**Staff Report**  
**City of Richmond, Virginia**

**Commission of Architectural Review**

5. COA-121956-2022	Final Review	Meeting Date: 12/20/2022
<b>Applicant/Petitioner</b>	Martin Hedrick	
<b>Project Description</b>	Rehabilitate an existing dwelling and enclose a rear porch.	
<b>Project Location</b>		
<b>Address:</b> 3017 E. Marshall Street		
<b>Historic District:</b> Church Hill North		
<p><b>High-Level Details:</b></p> <p>The existing home is a 2-story Italianate dwelling constructed ca. 1890.</p> <p>The applicant is proposing to construct a new one-story, full-width front porch with a hipped TPO roof supported by 8" square columns.</p> <p>The applicant also proposes to convert a second-story door to a window and to enclose a rear second story side porch. The new window will match the existing second story window.</p>		
<b>Staff Recommendation</b>	<b>Approval, with Conditions</b>	
<b>Staff Contact</b>	Alex Dandridge, alex.dandridge@rva.gov, 804-646-6569	
<b>Previous Reviews</b>	<p>A COA application was reviewed and approved with conditions for this property in July 2019. The scope of work was similar and consisted of removing the two-story, full-width front porch, constructing

Figure 3. Sanborn map

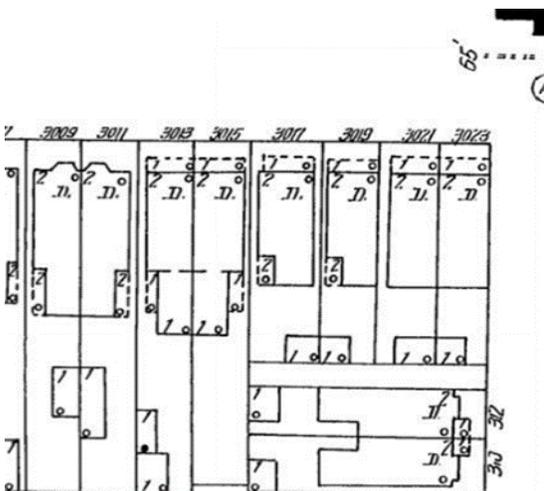
<p>Reconstruction of Missing Historic Elements Administrative Approval Guidelines</p>	<p><i>The Commission staff may approve a reconstruction of missing elements based on the following criteria: architectural inventory documentation, including assessment records, insurance policies, and historic inventories; and architectural remnants on an attached or adjoining building.</i></p>	<p>The applicant requests permission to reconstruct a one-story front porch. Based on photographic documentation and the 1905 Sanborn Map, it appears that this dwelling has featured a couple front porch designs, the most recent being a two-story porch with decorative spindle work frieze, lace-like brackets, and turned posts.</p>

<p>Based on documentation, staff believes the house originally had a half-hipped roof and staff recommends approval of this roof form.</p> <p>As submitted the new porch will feature 8" square columns with molding around the capitals and bases. Dwellings of similar design in the district have 6" turned posts. Because the design of the original porch is unknown, and in order to relate to existing designs found in the district, <u>Staff recommends that simple 6x6" square posts be used on the front porch rather than the proposed 8" columns with decorative molding.</u></p>
<p>New Construction, Porches and Porch Details pg. 49</p>	<p><i>1. Porch railings and balustrades are important character-defining features of historic buildings. The proportions of these railings are a significant contributing feature to the appearance of both the individual structure and the character of the entire neighborhood.</i></p> <p><i>5. Porch roofs are encouraged to utilize standing- or flat-lock metal seam roofs that are hand-seamed, or closely approximate hand-seaming.</i></p>	<p>The new porch railings are proposed to be turned pickets. While the design of the original porch is unknown, the most recent configuration of the front porch did have turned posts, and photographic documentation demonstrated that the dwelling that was located at 3019 E. Marshall Street (demolished) had a similar form and featured turned posts. Staff supports the use of turned posts.</p> <p>The porch roof will be a dark TPO material. Staff finds TPO to be an appropriate substitute material for flat-lock metal roofs.</p>
